January 4, 1991

Re: **American Steel Foundries**
OHD017497587
Mahoning County

Enclosed is the final report for the Comprehensive Ground Water Monitoring Evaluation (CME) that was conducted on October 25, 1990 at the American Steel Foundries Sebring disposal facility located in Smith Township, Mahoning County, Ohio.

Figure 5.

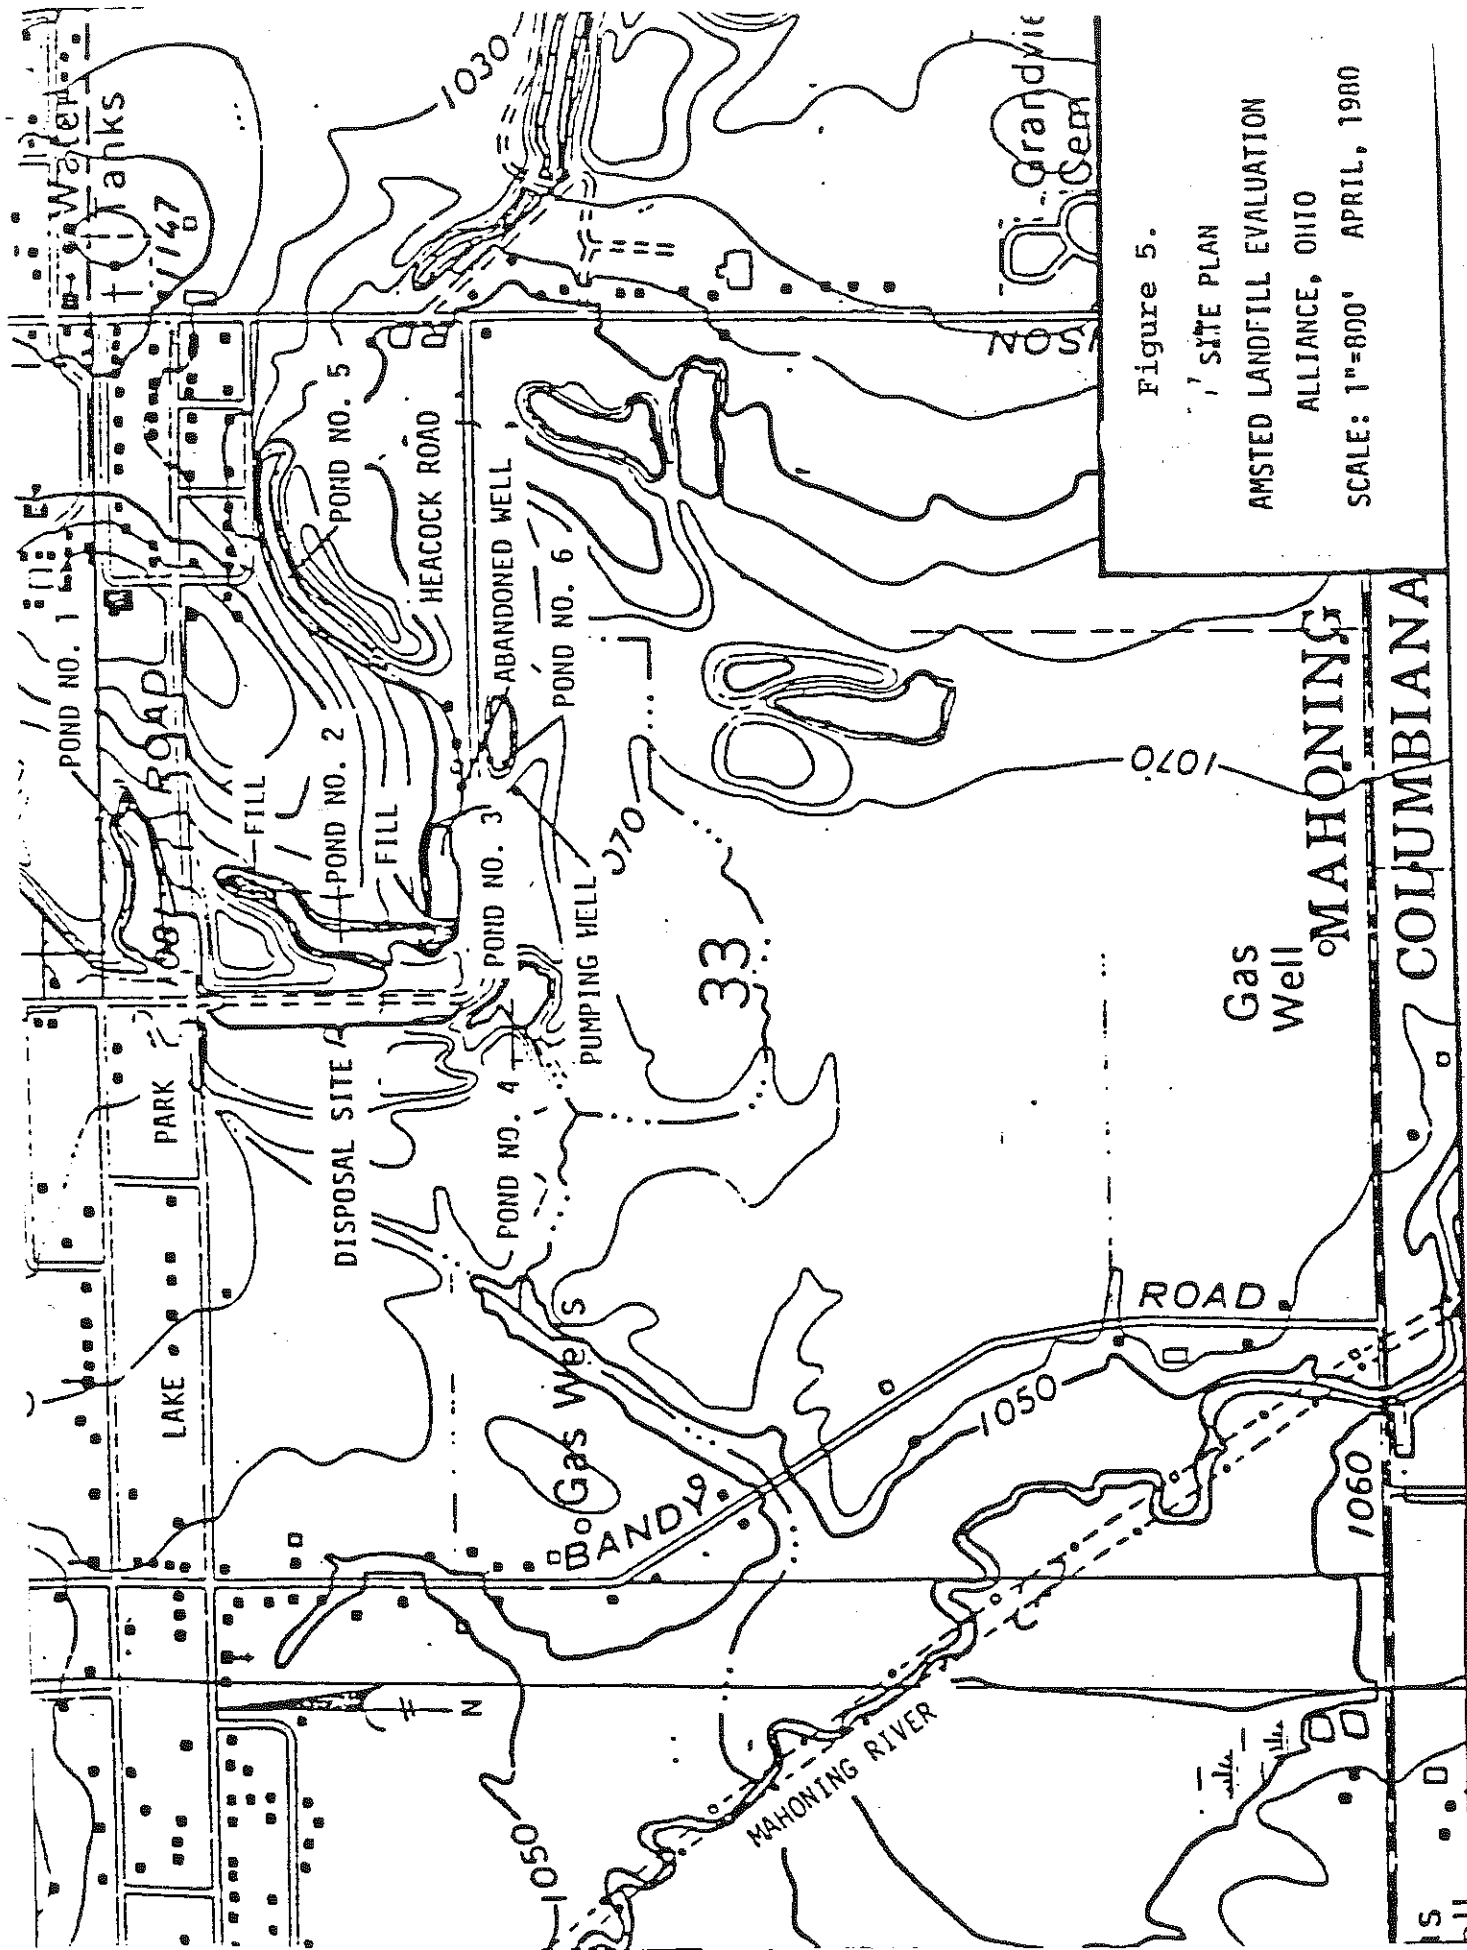
Geologic cross-sections provided by the consultant are shown as figure 6. Although, these sections show the approximate geometry of the filled pit area they do not explicitly delineate the rock strata and potential aquifers exposed within the strip pit and thus provide only limited information. Screen intervals of the monitor wells should be included on these sections along with a clear indication of the aquifer system being monitored.

LOG OF WELL NO. 1 AMERICAN STEEL FOUNDRIES, ALLIANCE, OHIO, LAKE PARK ROAD PROJECT

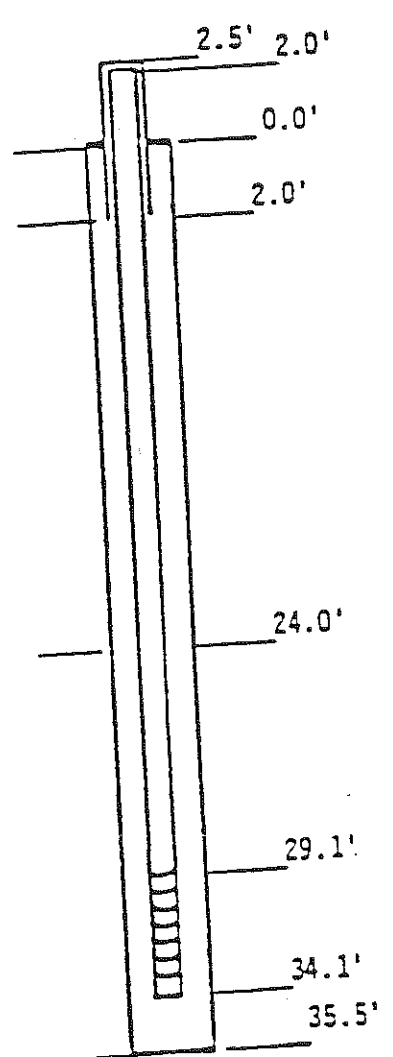
Methods of sealing the annular space of the well and information concerning the geometry of the sand pack has not been provided by the consultant. Methods of emplacement of the sand pack, the type of sand used in the pack, and procedures employed for decontamination of both the monitor well casing and sand pack were not stated. It is presently unclear whether contaminants may have been introduced into the well by these materials. These details should be clearly explained in the facility sampling and analysis plan. Because of this lack of information, it is not possible to determine whether these monitor wells meet the construction requirements outlined in OAC 3745-65-91(c).

Figure 6

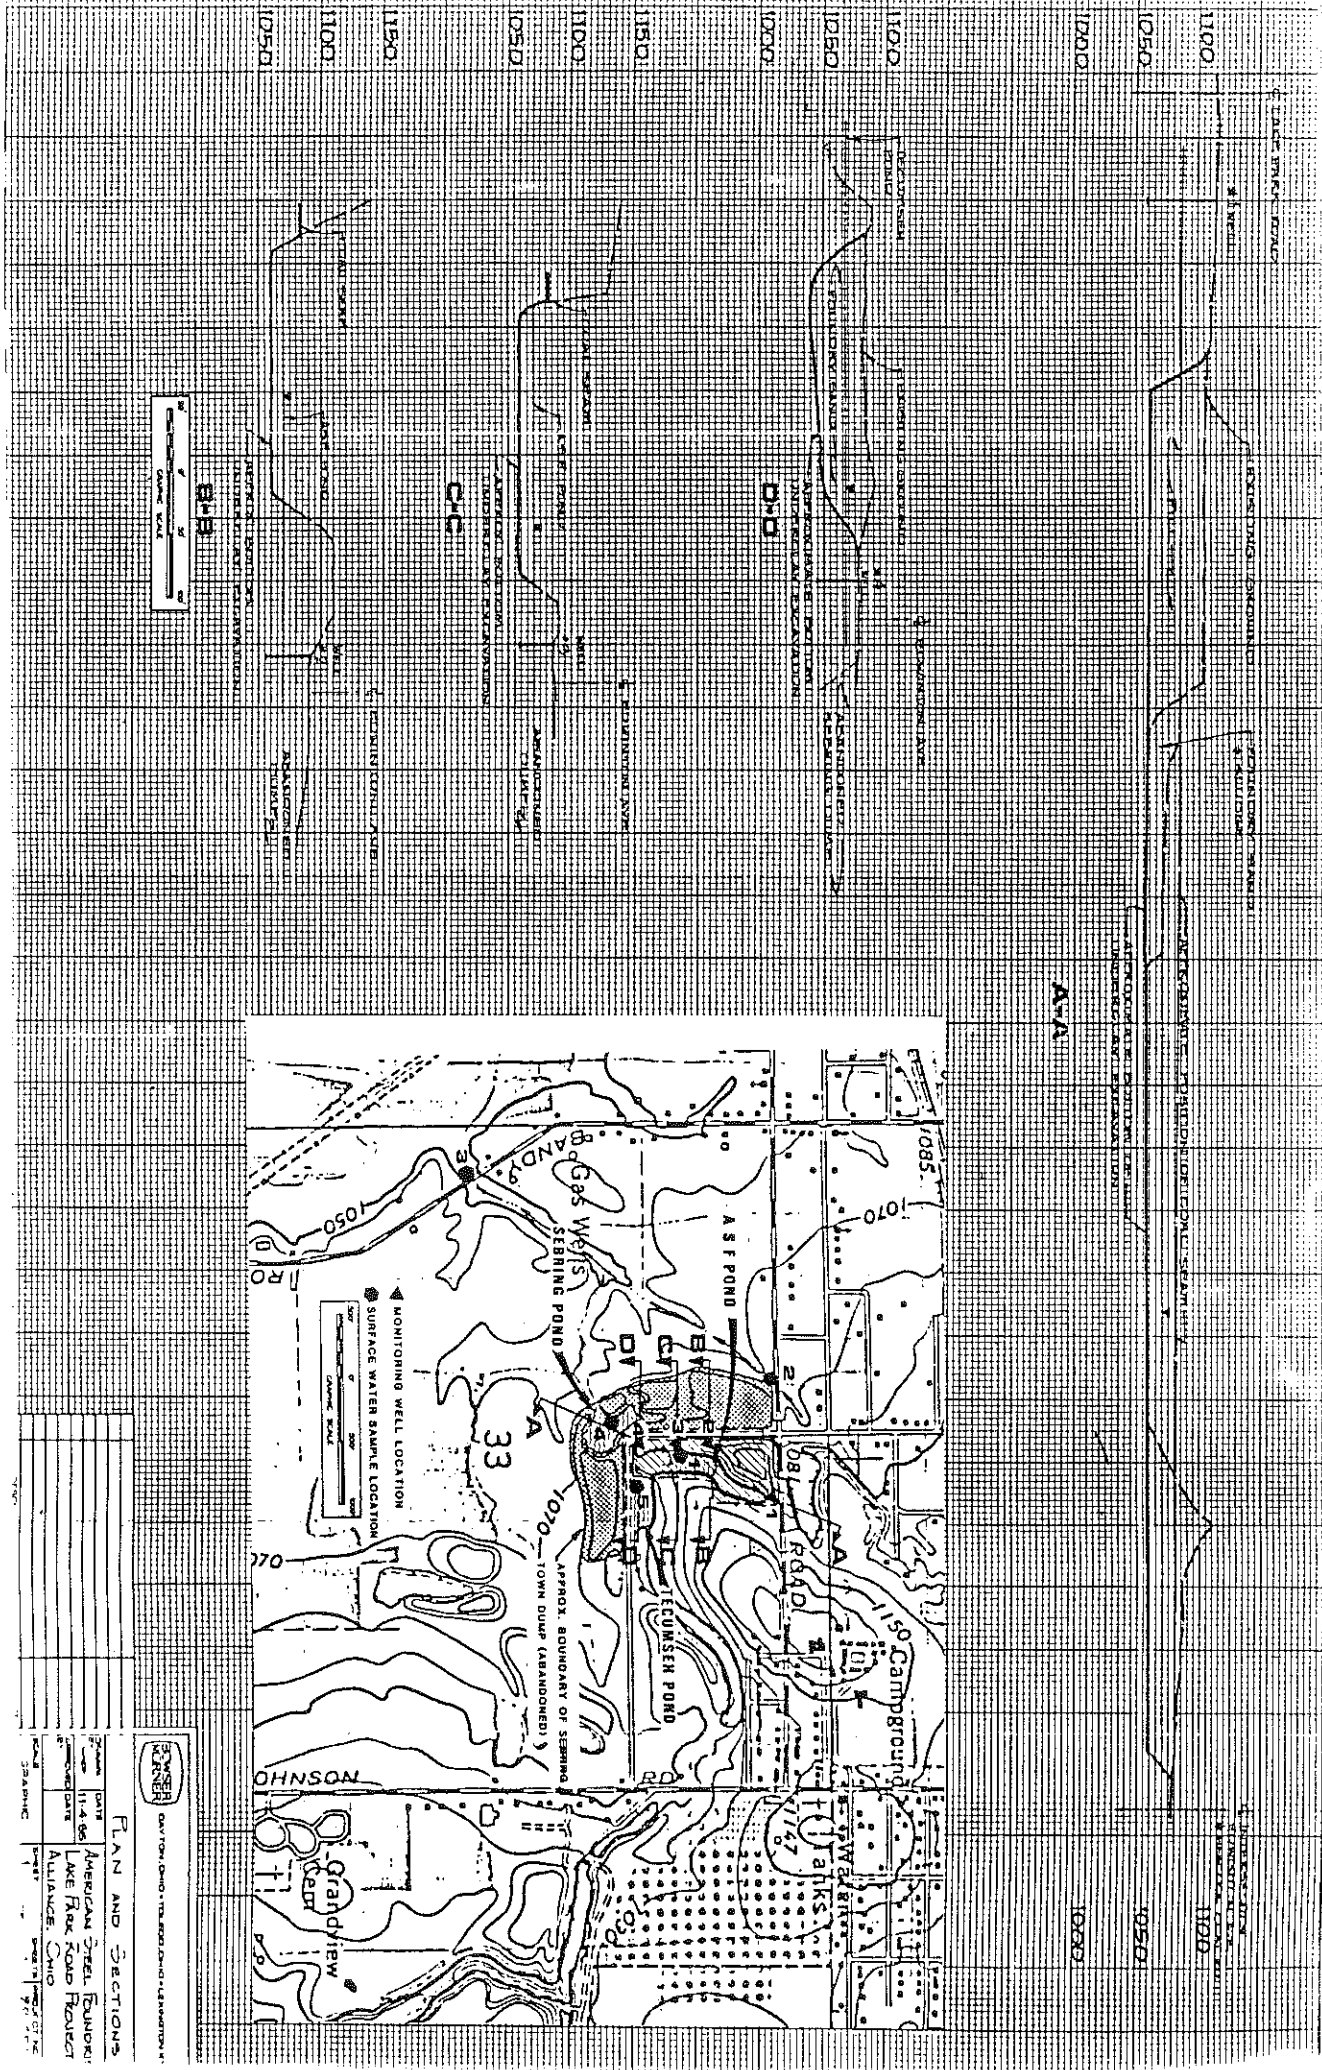
Geologic cross-sections provided by the consultant are shown as Figure 6. Although, these sections show the approximate geometry of the filled pit area they do not explicitly delineate the rock strata and potential aquifers exposed within the strip pit and thus provide only limited information. Screen intervals of the monitor wells should be included on these sections along with a clear indication of the the aquifer system being monitored.

Between July 9-11, 1985, five (5) borings were installed at the site. Locations of these borings are shown as Figure 6. The borings were completed with a truck-mounted boring rig utilizing hollow-stem augers. Soil samples were taken by means of a 2-inch O.D. split-spoon sampler utilizing standard penetration resistance methods (140 pound hammer, 30-inch drop). Samples were collected at maximum intervals of 5 feet or at major changes in lithology, which ever occurred first. Disturbed auger samples were also collected. These samples were visually classified, logged, and sealed in moisture-proof jars, and brought to the laboratory for study. The position at which an auger sample was obtained is indicated on the boring logs as an "A-type" sample. In addition, four disturbed samples were taken by hydraulically pressing, at a constant rate, 3-inch O.D. thin-walled samplers through the soil strata. The thin-walled samplers were sealed and brought to the laboratory for tests and evaluation. The position at which a thin-walled sample was taken is shown on the boring logs as a "C-type" sample.
